### **LETTER OF CLARIFICATION NO. 1**

## NEW CITY HALL RENOVATIONS & RELOCATION PROJECT NO. E016015

DATE: January 10, 2022

MECHANICAL THIRD FLOOR PLAN -BUILDING 2

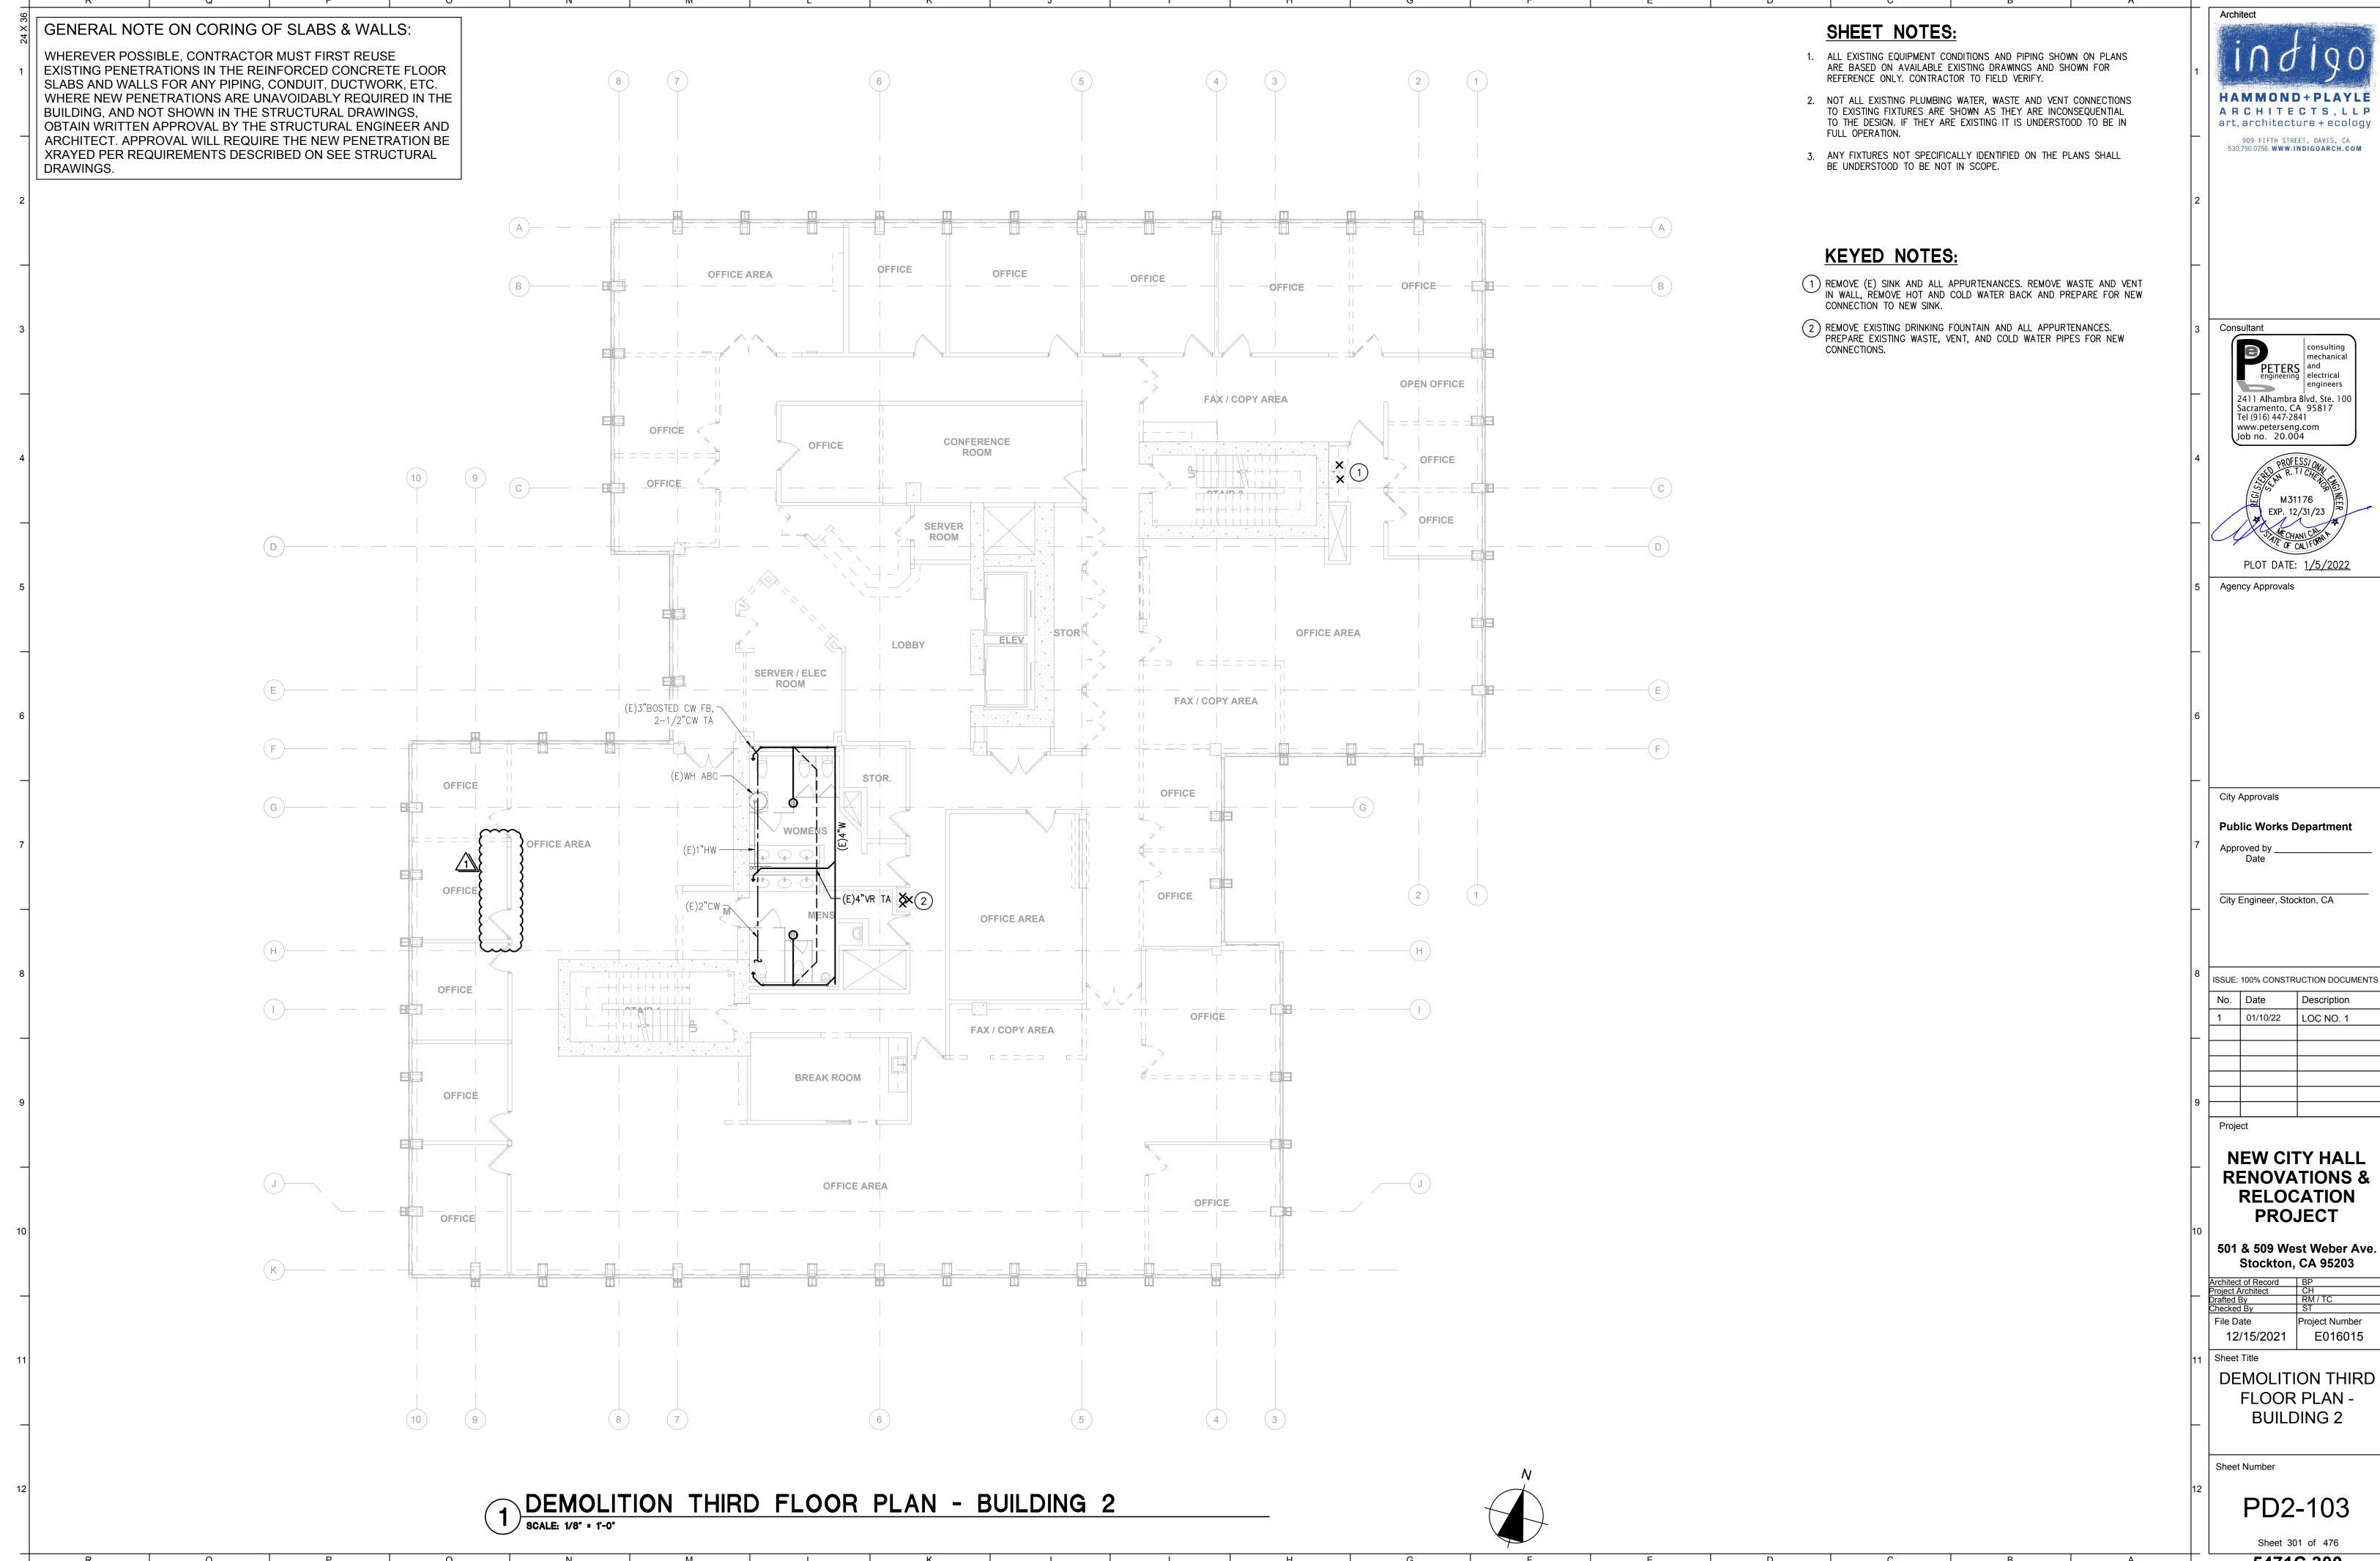
1. <u>Third Floor - Building 2 design revisions</u>: add Office 2-336B and Office 2-342B, including additional power, HVAC distribution and two (2) added doors. Delete

two (2) workstations in Open Office Traffic 2-344 and in Open Office Traffic Area 2-339 including revisions to power and data locations. Reconfiguration of workstations and relocation of copier south of Break Room 2-338 and in Open Office Traffic 2-339, including revisions to power and data locations. Add two (2) AV monitors in Office 2-320 and 2-322 including power and data provisions. Changes are marked by cloud with delta 1.
